DOD-C-63980 (AR)
AMENDMENT 8
29 November 1994
SUPERSEDING
AMENDMENT 7
26 August 1992

MILITARY SPECIFICATION

CARTRIDGE, 30MM TARGET PRACTICE, M788

FIGURE 1. Vibration Test Curves for Equipment Installed in Helicopters, Equipment Catecory C. (Ref. Figure 5.14.2-3 of MIL-STD-810C)

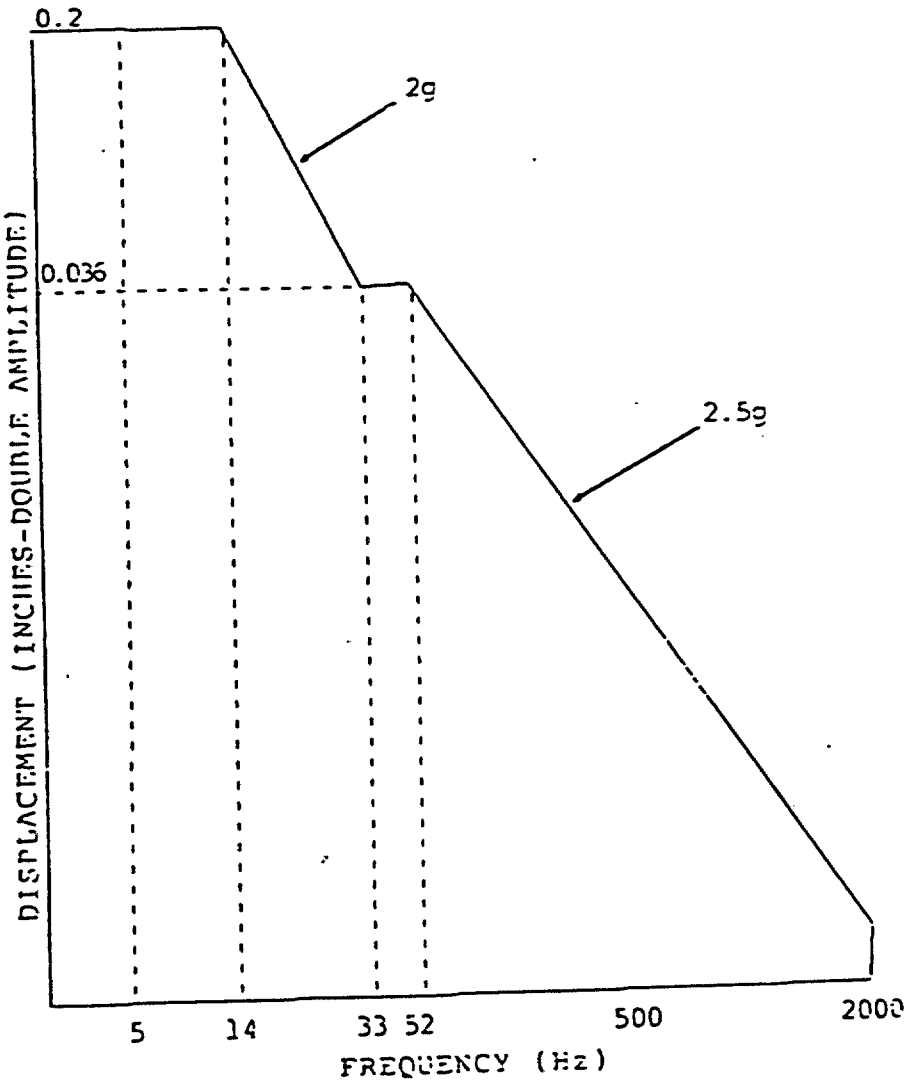
Third sentence: Delete "The vibration...figure 2." and substitute "The vibration... as shown in figures 1 and 2."

Add Figure 1, Vibration test curves for equipment installed in helicopters, equipment category C, as included page 5(24).

FIGURE 2. Logarithmic Sweep. (Ref. Figure 514.2-10 of MIL-STD-810C)

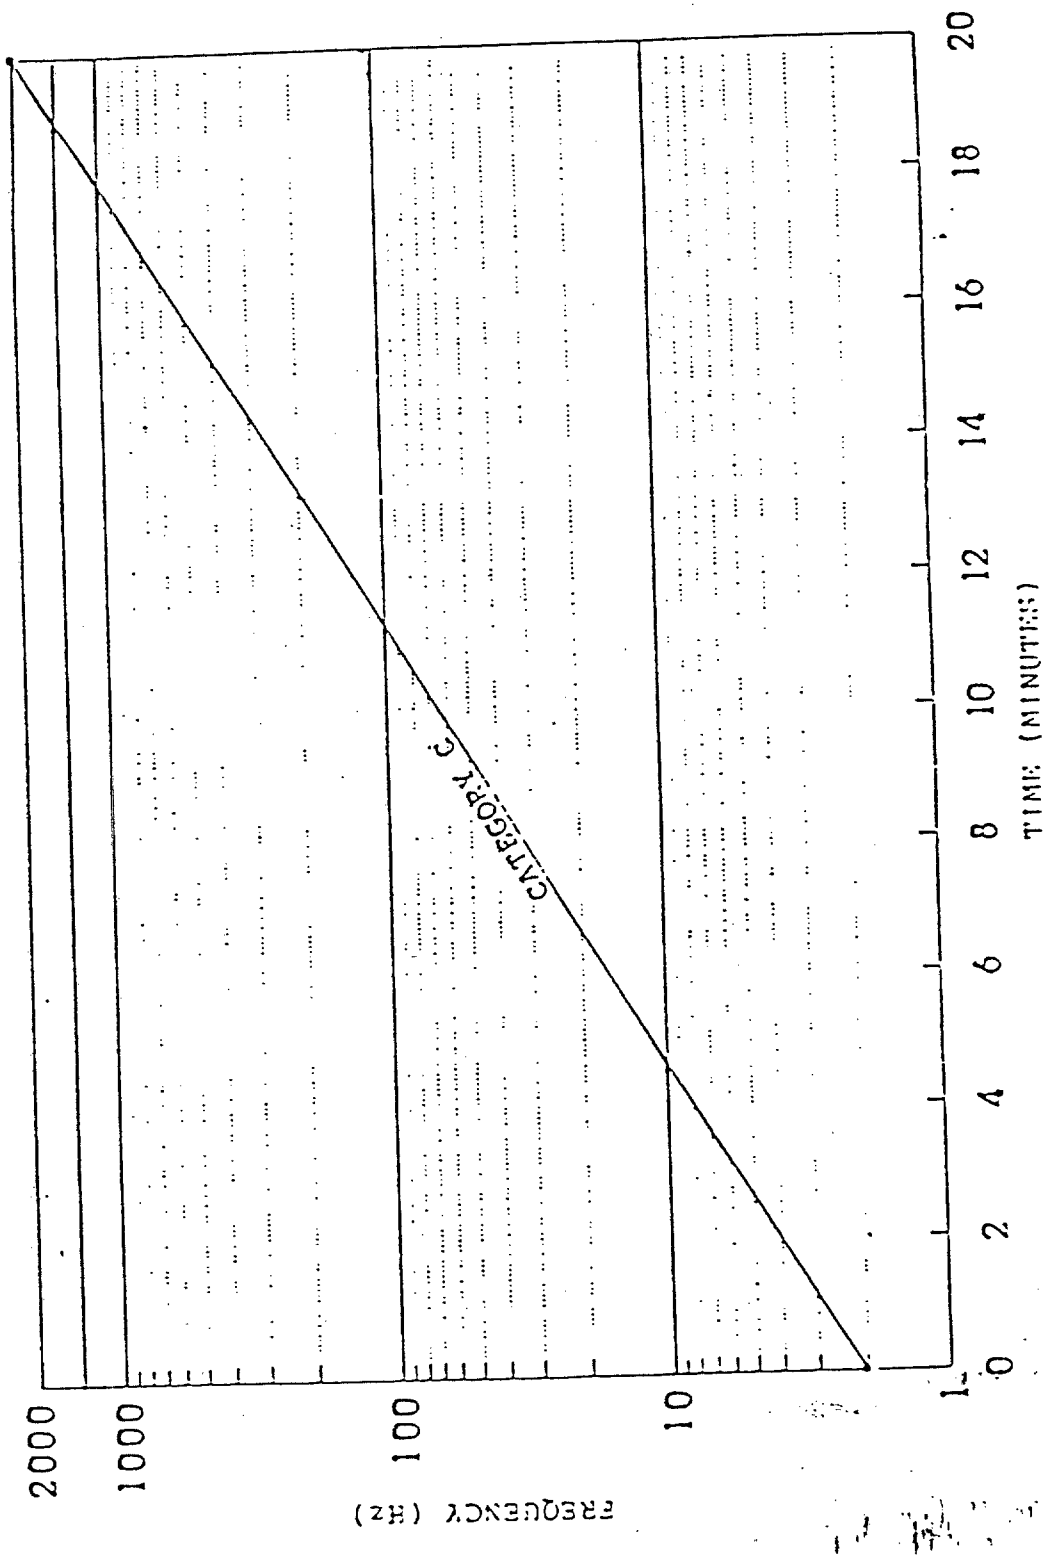
Add Figure 2, Logarithmic sweep, as included page 6(25).
